From: Andy Corbett <AC@civilsandgroundworks.com>
Sent: 02 August 2024 11:07
To: Jon Corcoran
Subject: FW: First Street, Manchester - Attenuation Tank Area Survey

As below, we're pricing a small scheme for CS Civils with StormBrixx HD.

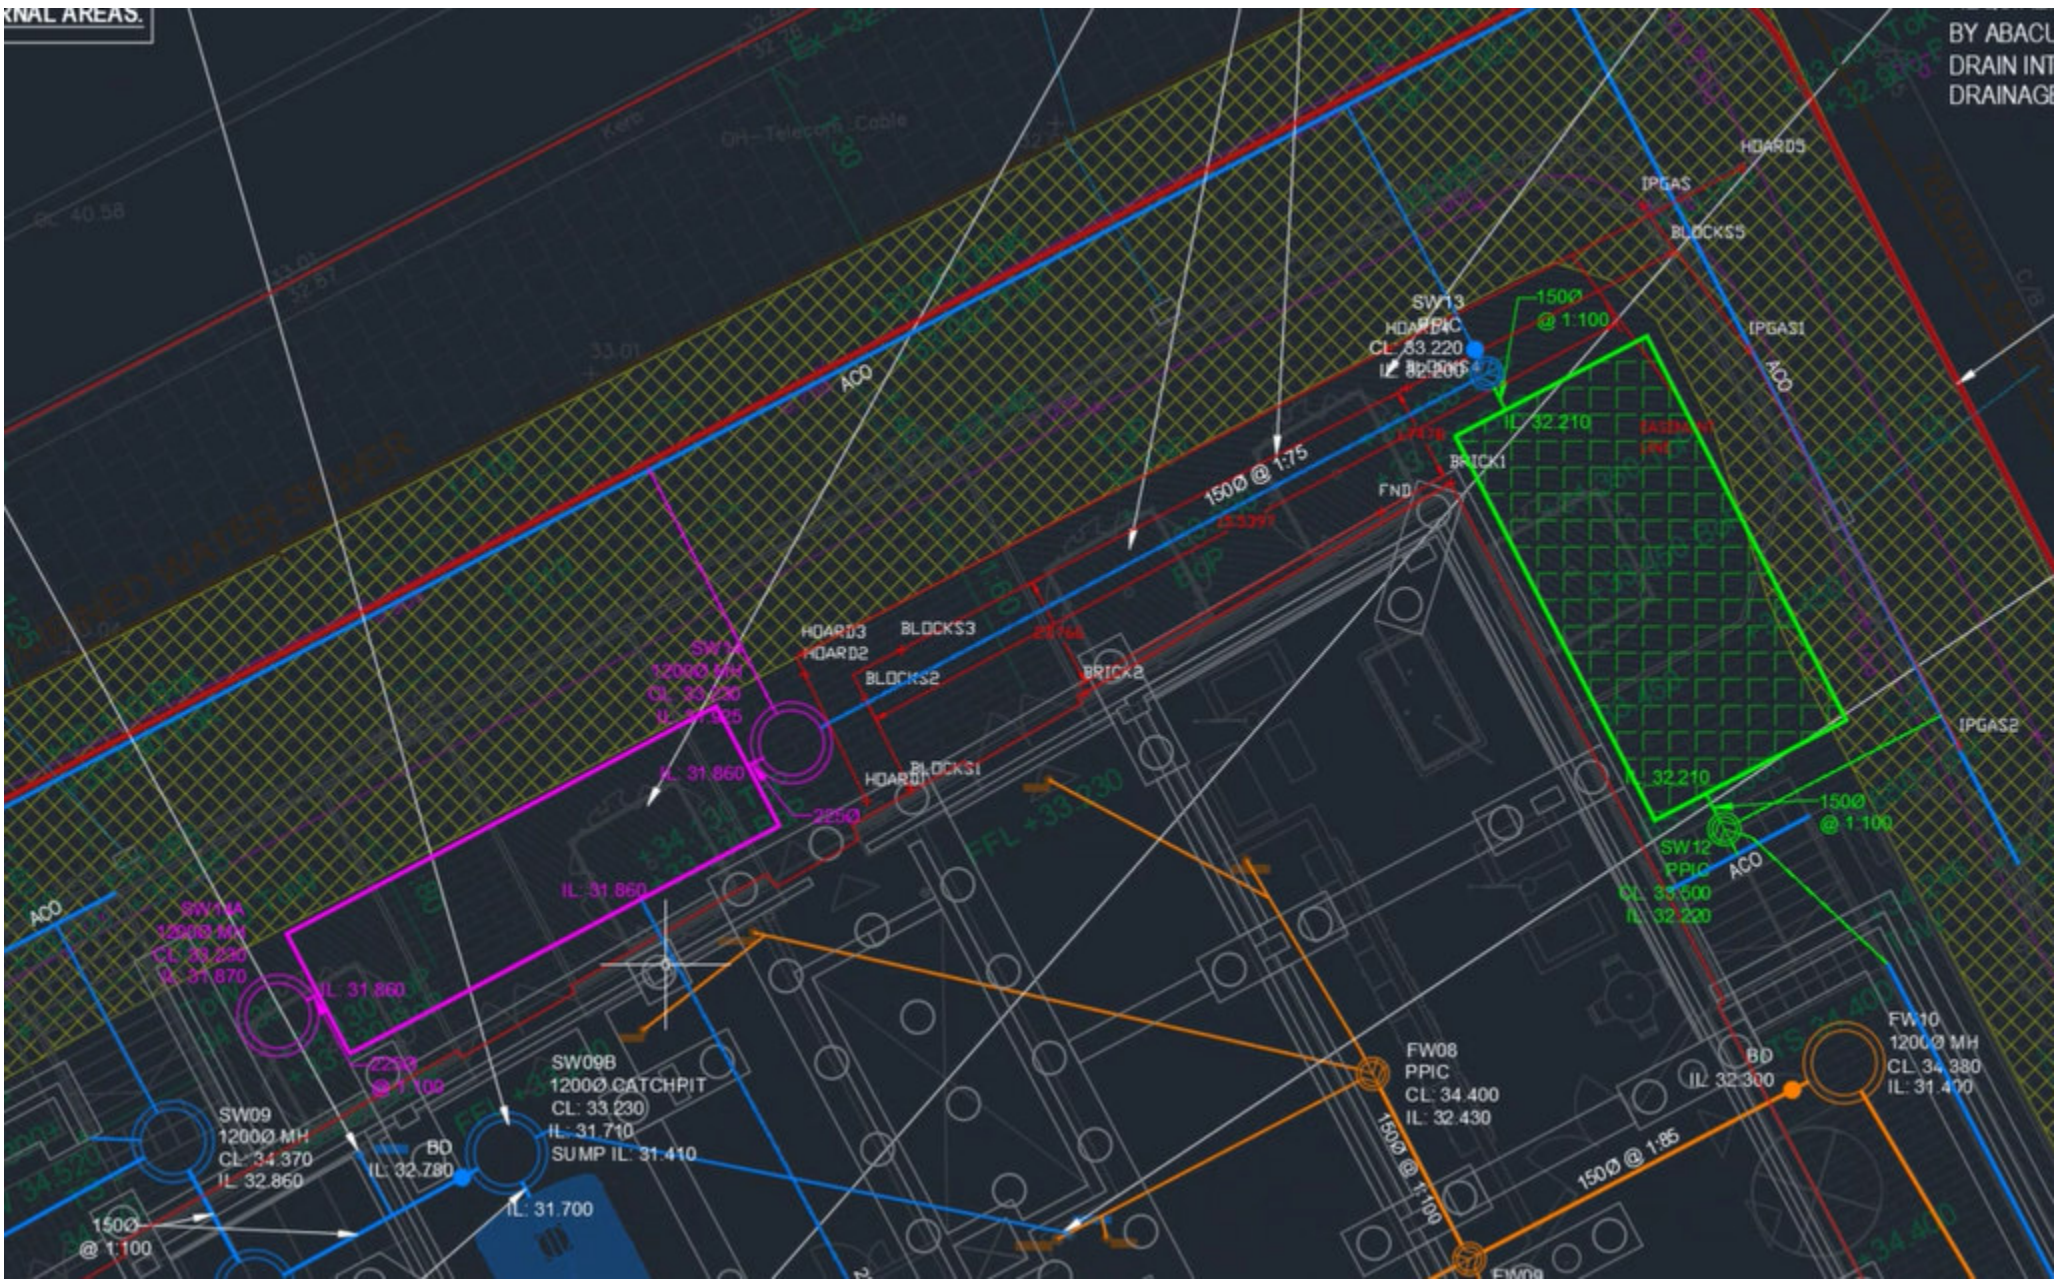
From: Anthony Studholme <anthonystudholme@downing.com>
Date: 19 April 2024 at 12:08:29 BST
To: Danny Sinclair <dannysinclair@ajpltd.co.uk>
Cc: Richard Barchha <richardbarchha@downing.com>, Pavan Bhawsar <pavanbhawsar@downing.com>
Subject: Re: First Street - Attenuation Tank Area Survey
Green would work best provided Cadent have no issues.

Would the purple or green locations be viable?

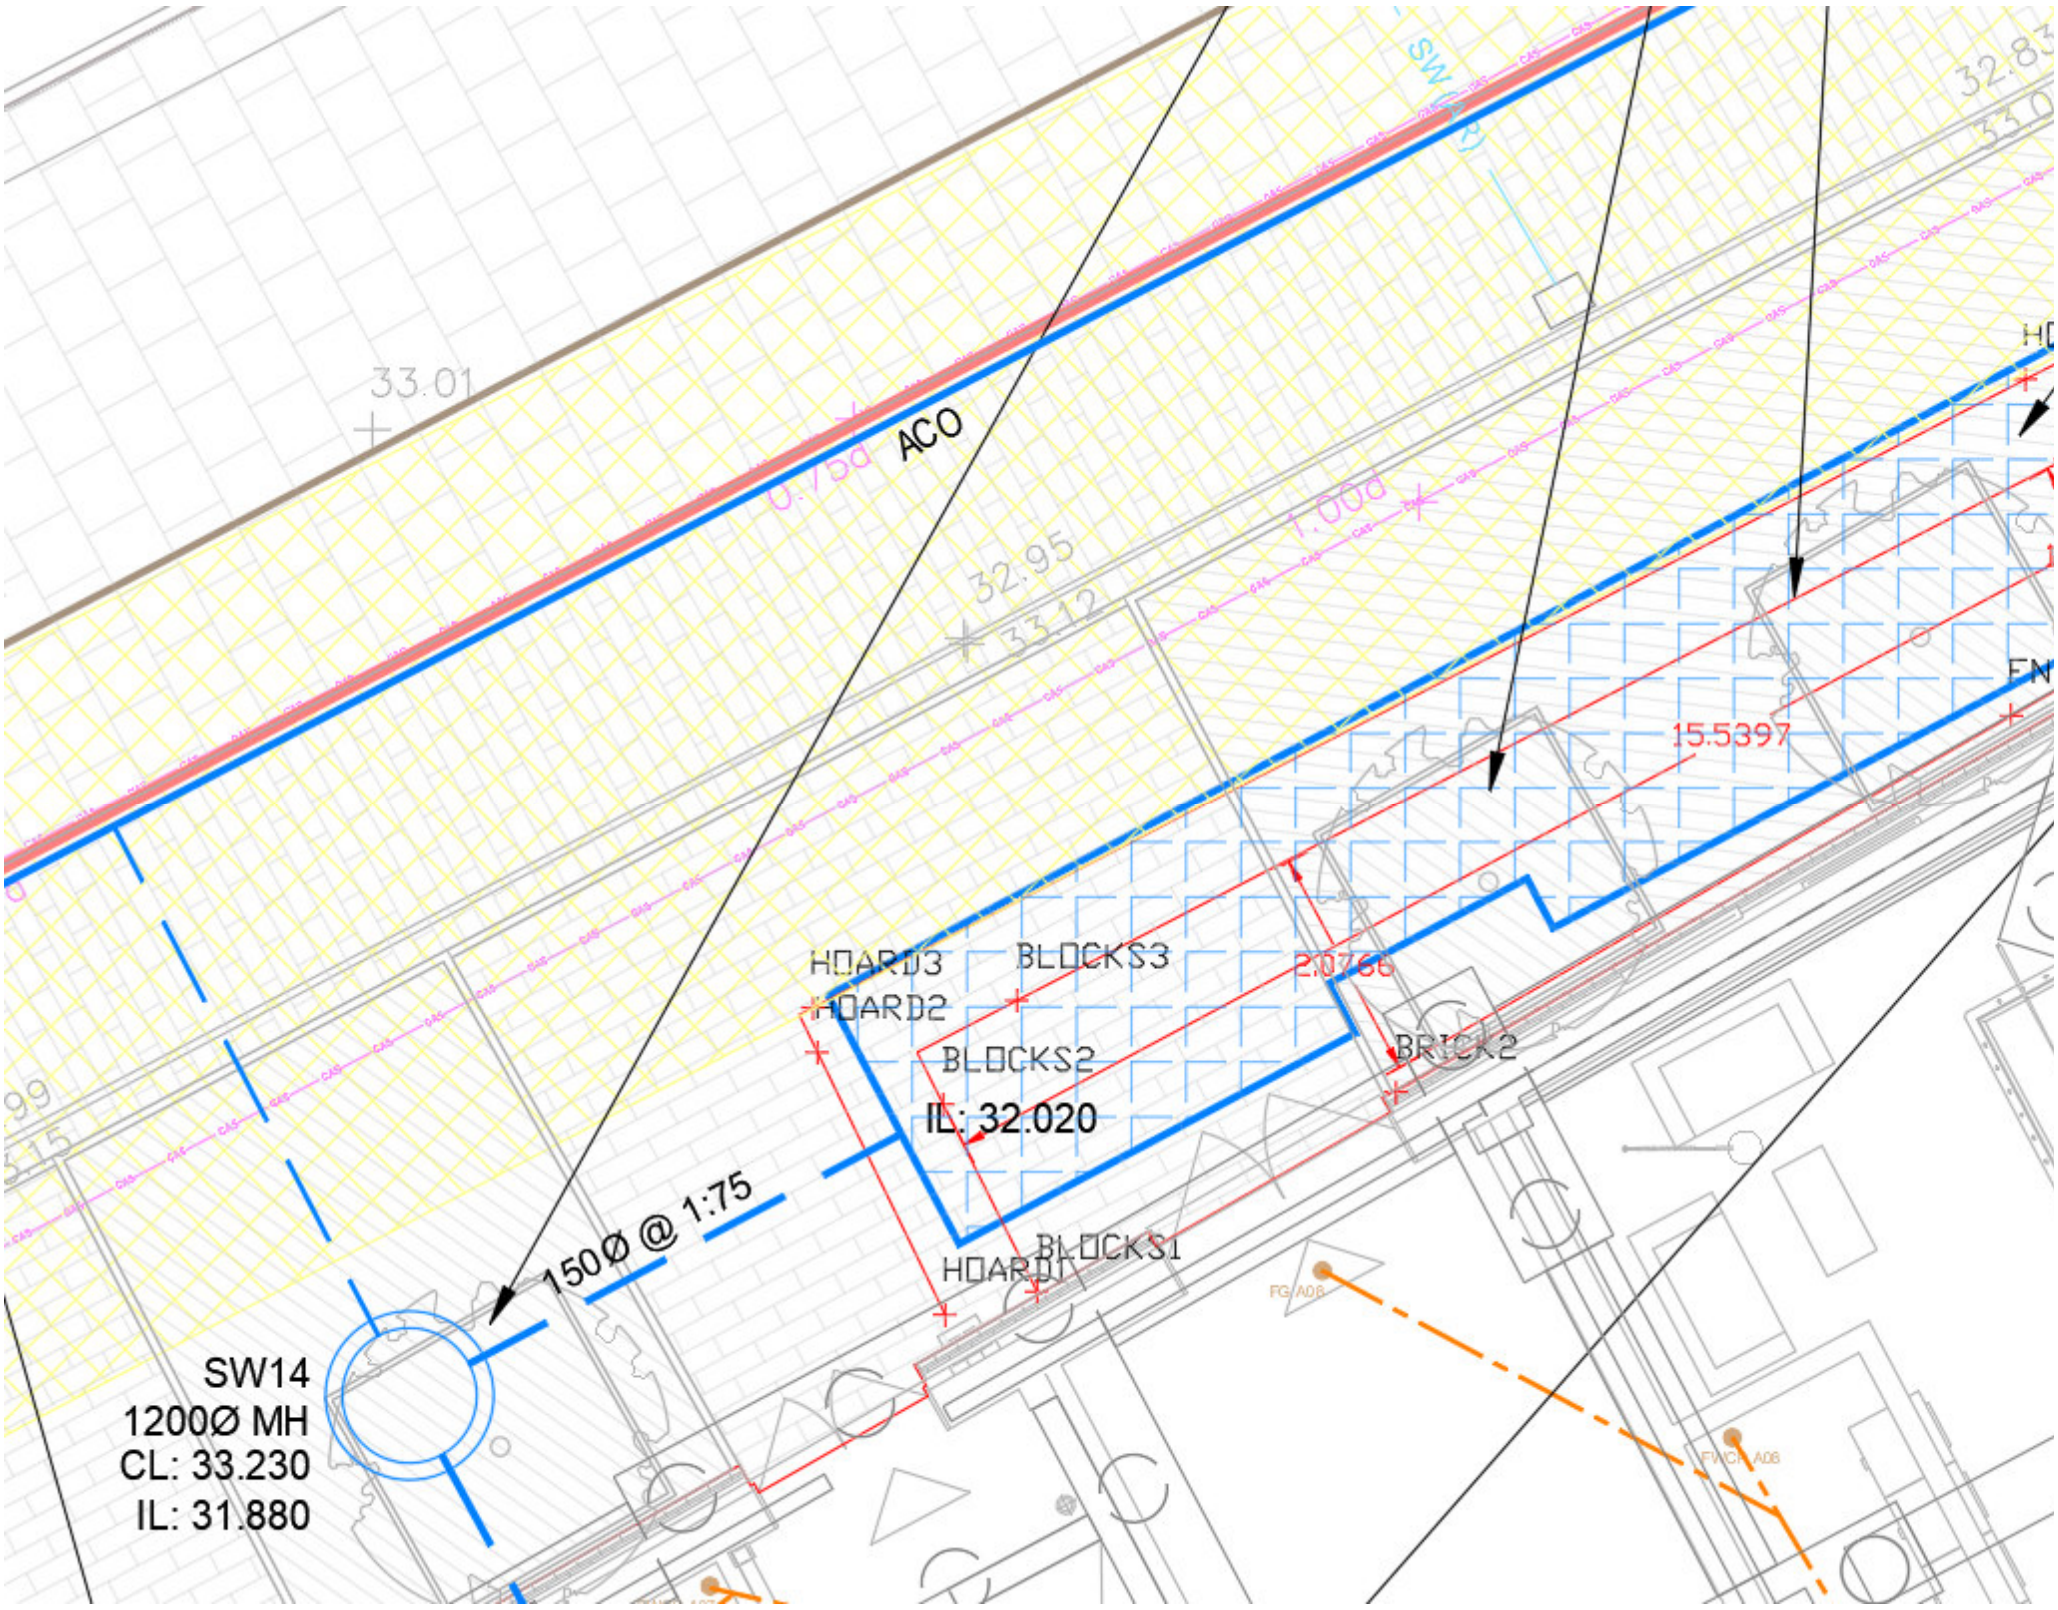
I don't think its achievable and it depends upon the when the tunnel entrance for sample flat visitor will be dismantled.
The other option is to get it done after august.

See the revised tank arrangement below, is this achievable?

No good, we can't move the tunnel and we can't wait until August to start.

Whats the next option? Can we look at an option further west of current proposal?
